**Transport
for NSW**

Additional Information provided to Department of Planning and Environment to support the assessment of the CBD and South East Light Rail Project

This information was submitted in response to requests for further information requested by the Department of Planning and Environment since lodgement of the CSELR Submissions Report in March 2014.

CBD and South East Light Rail Project Independent Review of Noise/Vibration Assessment Response to Issues Raised

Figure 1 FTA Guideline Allowable Increase in Cumulative Noise Levels

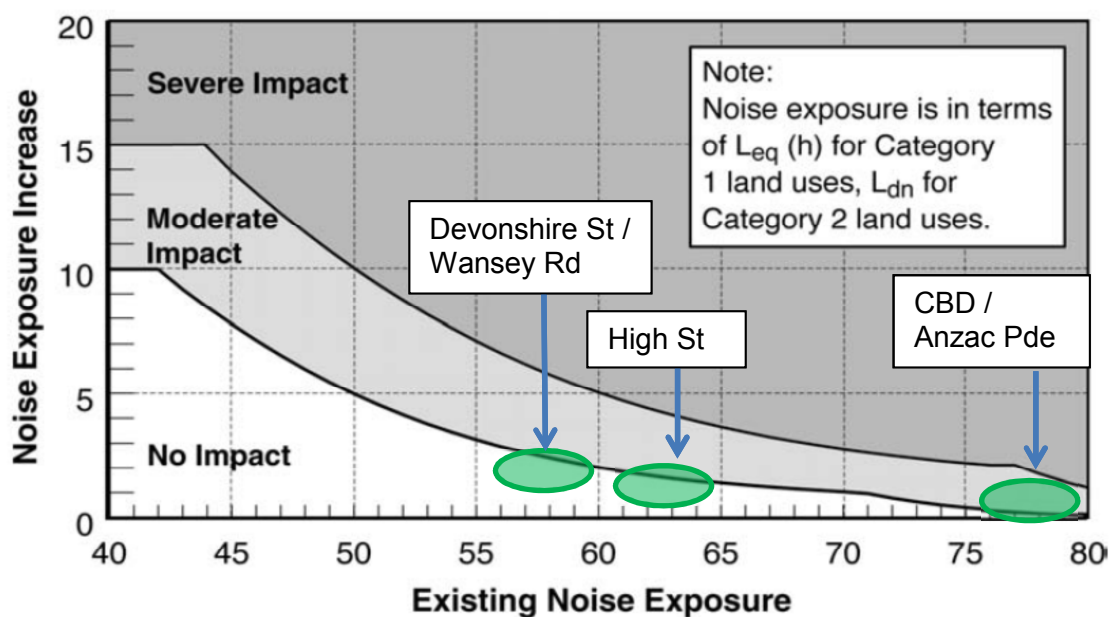
Figure 1 has been reproduced from the FTA Guideline, with the indicative impacts at key locations along the CSELR alignment. It indicates that in existing quiet areas such as Devonshire Street or Wansey Road, an increase in overall ambient noise levels of 2 dB to 3 dB would be acceptable. A 2 dB increase would also be acceptable in High Street, Randwick. In existing high-noise areas, the acceptable increase due to a transit project is almost zero. However, it is noted that in these areas the light rail noise would not be expected to contribute significantly to the overall LAeq(9hour) noise levels.

Figure 3 Randwick Stabling Model and Receivers

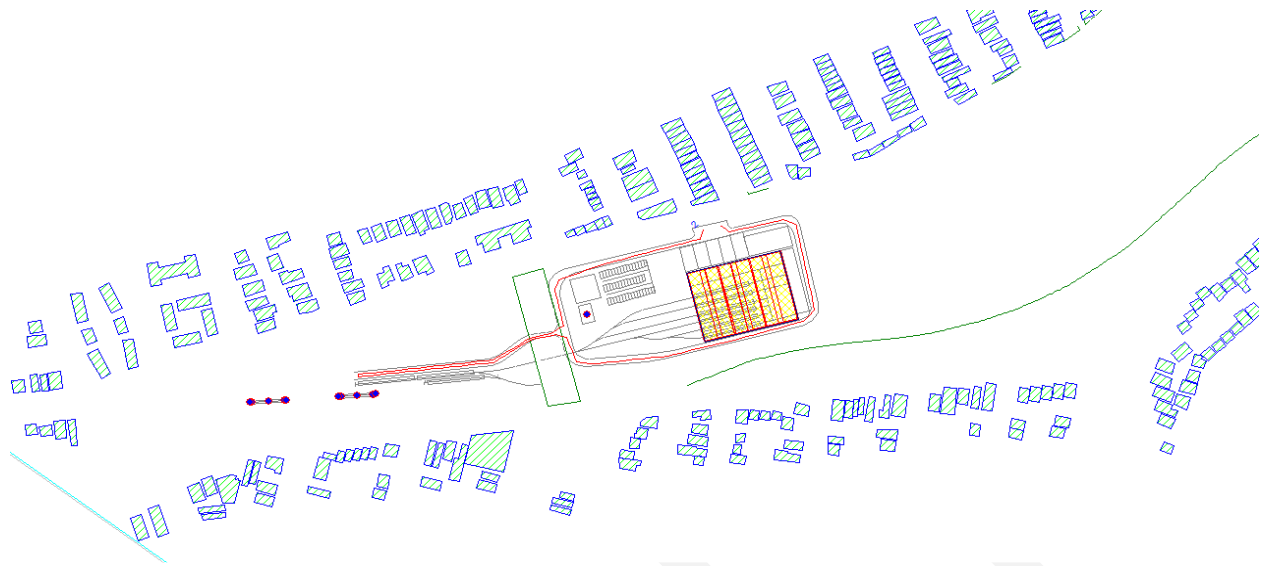
Query/ Recommendation: The report confirms that noise is a significant concern with this site and raised the issue of barriers / partial roofs or a complete shed, without including any plans or elevations showing the extent of these building areas. With the extent of the impacts and non-compliance of the night time noise criteria presented in the report it is recommended that the noise assessment be revised in detail to show how noise will be mitigated/managed and achieve INP criteria. The assessment needs to address the issues highlighted above, present plans, cross sections and elevations showing the extent of mitigation, show noise contour or façade plots to indicate where the noise impacts are for each scenario, exact source locations for each scenario, etc.

Query/ Recommendation: Please review Table 36 in the Report which presents predicted noise levels from the Rozelle Maintenance Facility. Given the location of the noise sources, it is surprising that the highest noise levels are on the ground floor. It is unclear where the receiver locations are. The assessment needs to present noise contour or façade plots or a plan showing receiver locations to indicate where the noise impacts are for each noise scenario.

The receivers and source locations considered in the assessment are shown in **Figure 3**.

Figure 5 Indicative Construction Impacts on Residential Receivers – City Centre

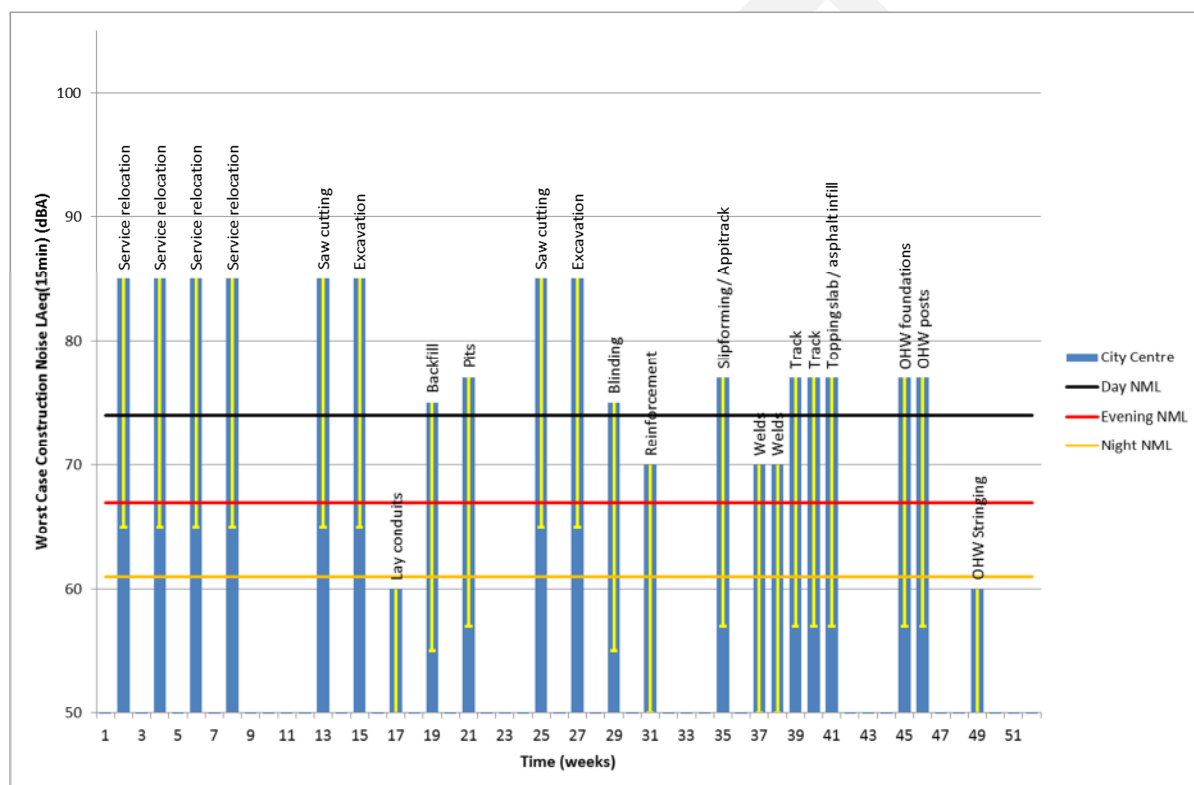
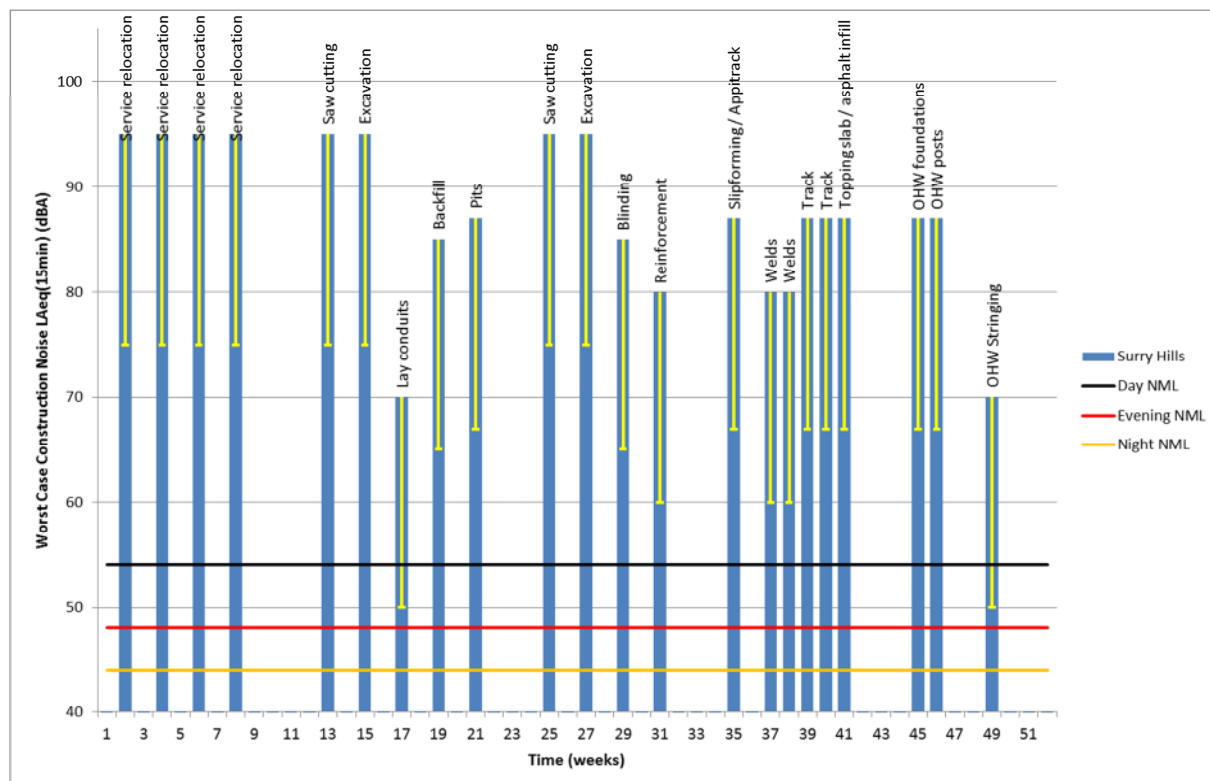
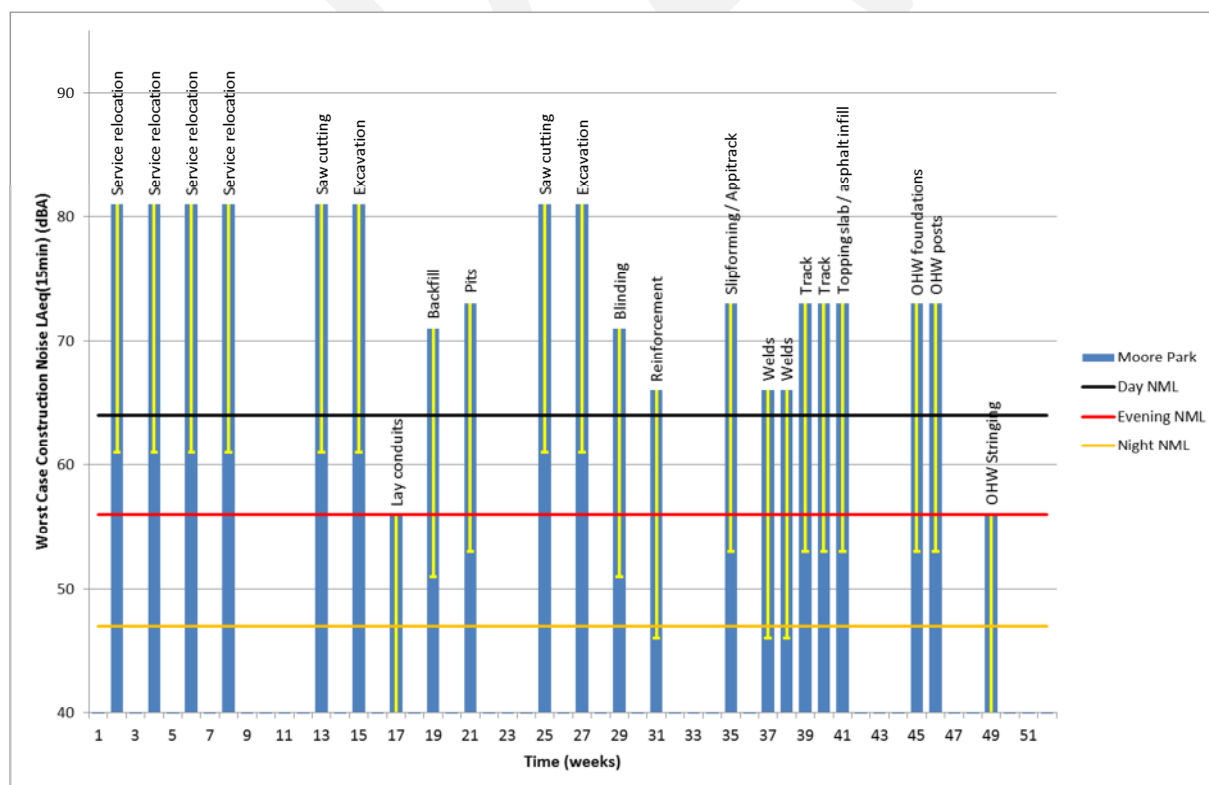
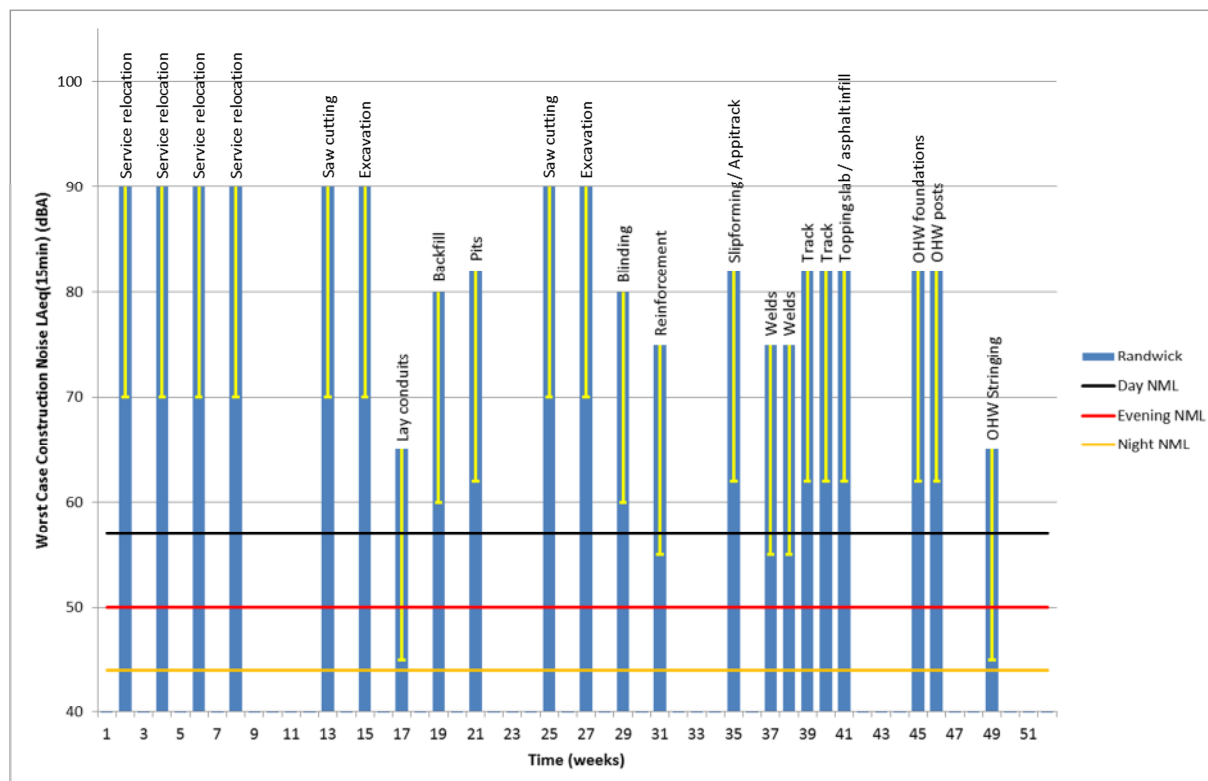
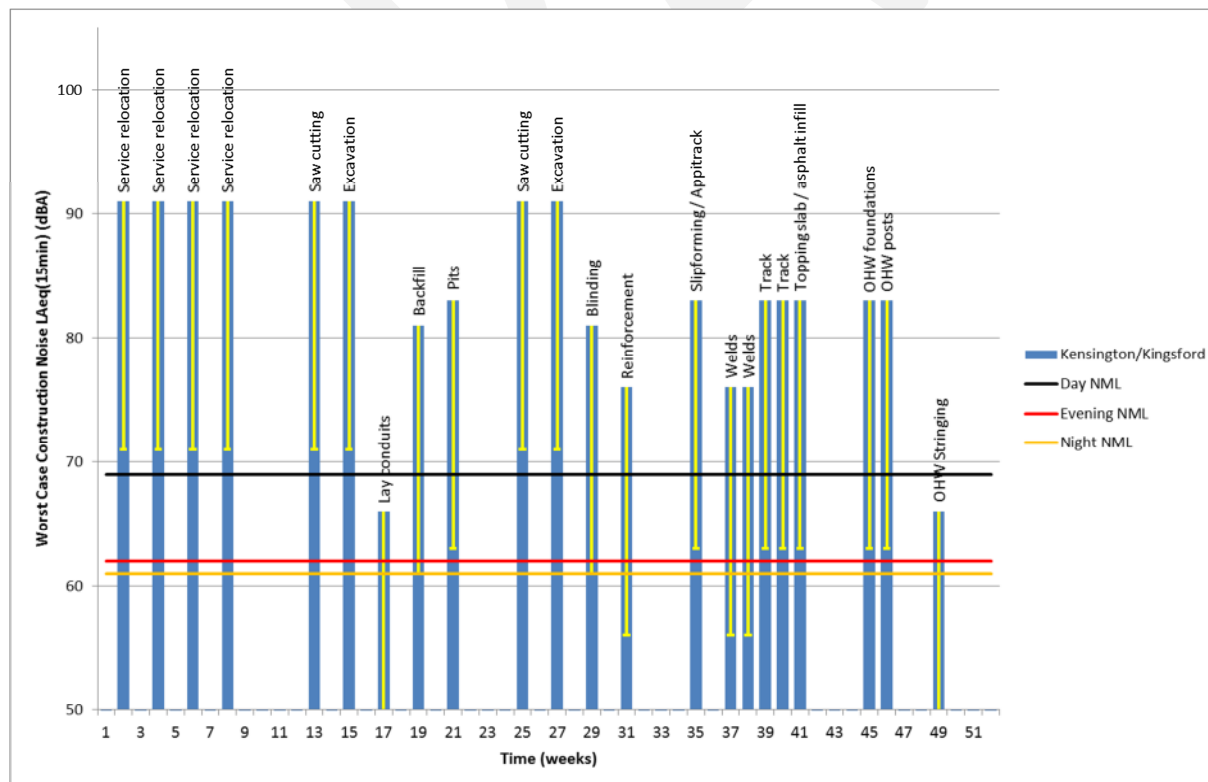
Query/ Recommendation: It is unclear the level and duration of the noise impact at locations along the construction of the light rail system. To understand the construction noise impacts along the construction of the track it is requested that a noise profile be constructed for a typical (worst) receiver (day, evening and night) and show in graphical terms the duration of construction in each of the areas, namely:

- City Centre Precinct ;
- Surry Hills Precinct;
- Moore Park Precinct;
- Kensington / Kingsford Precinct;
- Randwick Precinct;
- Randwick stabling yard; and
- Rozelle maintenance facility.

At this stage, details of the schedule for the works are not available. There are a number of different approaches that could be taken to construction that would give an entirely different noise profile (for example, whether Appitrack or Slipforming machines are used).

Even with works in the same block, the noise impacts on any single receiver would be less for the proportion of that time that works are not occurring immediately adjacent. As the source moves away from the receiver, the noise level would reduce. An indicative reduction would be around 20 dB where the source is around 100m further along the alignment than the nearest point, for a receiver around 10m from the track. The noise levels corresponding to this reduction from the worst case situation is shown in the following figures in the form of a 20 dB range (shown as a yellow bar) below the predicted worst case level.
